Southern Nuclear Operating Company  
Vogtle Electric Generating Plant Units 3 and 4  
Transmittal of Section 404 Permit Modification Request

**U.S. Army Corps of Engineers Section 404 Permit No. SAS-2007-01837 Modification  
Request**

Vogtle Electric Generation Plant  
Section 404 Permit Modification Request  
USACE Permit SAS-2007-01837

**ATTACHMENT 1**  
**Sheet 1, Proposed Conditions (showing wetland impacts), 1/15/2010**  
**from USACE Section 404 Permit**

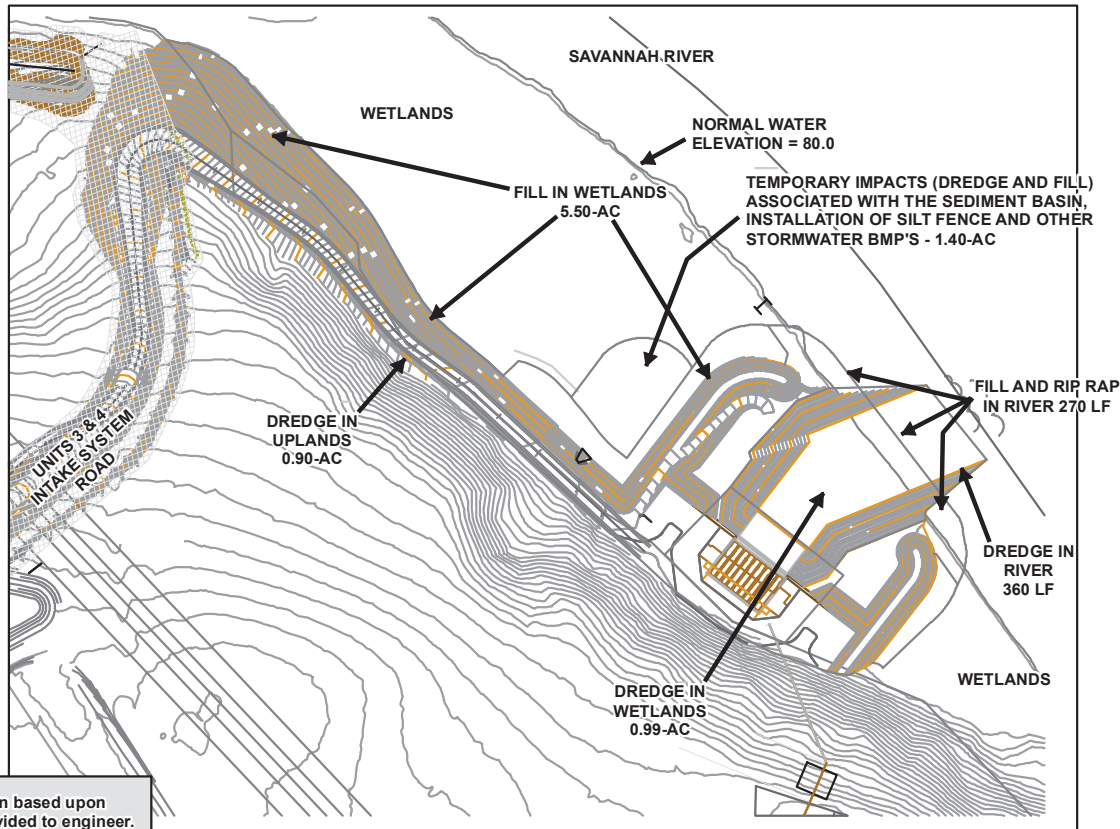
A total of 6.49 acres of permanent wetland impacts and 2.74 acres of temporary wetland impacts were authorized. To construct the RWIS and the RWIS road, permanent wetland impacts included 5.50 acres of fill and 0.99 acres of dredging. Permitted temporary impacts in this area included 1.40 acres of both dredge and fill and were associated with a sediment basin, installation of silt fence and other stormwater BMPs. The construction activities associated with the authorized permanent impacts are complete. If the proposed permit modification and additional compensatory mitigation are not approved, the temporary impacts that require removal include a temporary sediment basin, grouted riprap and gabion slope protection, a 60'x140' concrete pad, a corrugated metal outlet standpipe, and plywood baffles. The wetland impacts are described and graphically shown on Sheet 1, Proposed Conditions, dated January 15, 2010 as part of the USACE Permit SAS-2007-01837 (Attachment 1). The detailed construction plan for this area, Sheet SV0-0000-XD-012, is provided as Attachment 2.

The proposed permit modification requires converting 1.40 acres of wetland impact from temporary to permanent. SNC has completed the construction activities associated with the disturbance of 1.34 acres of temporary impacts associated with Wetland BJ, performed restoration activities, and terminated the NPDES construction storm water permit. The Notice of Termination (NOT) for permit GAR124823-V2 was submitted July 26, 2018.

SNC respectfully requests that USACE authorize this permit modification, which includes updating 1.40 acres of temporary wetland impacts to permanent impacts, and purchasing 2.10 additional wetland mitigation credits as compensation. The existing USACE Permit SAS-2007-01837 expires on September 30, 2020. SNC would like to complete this modification prior to permit expiration.
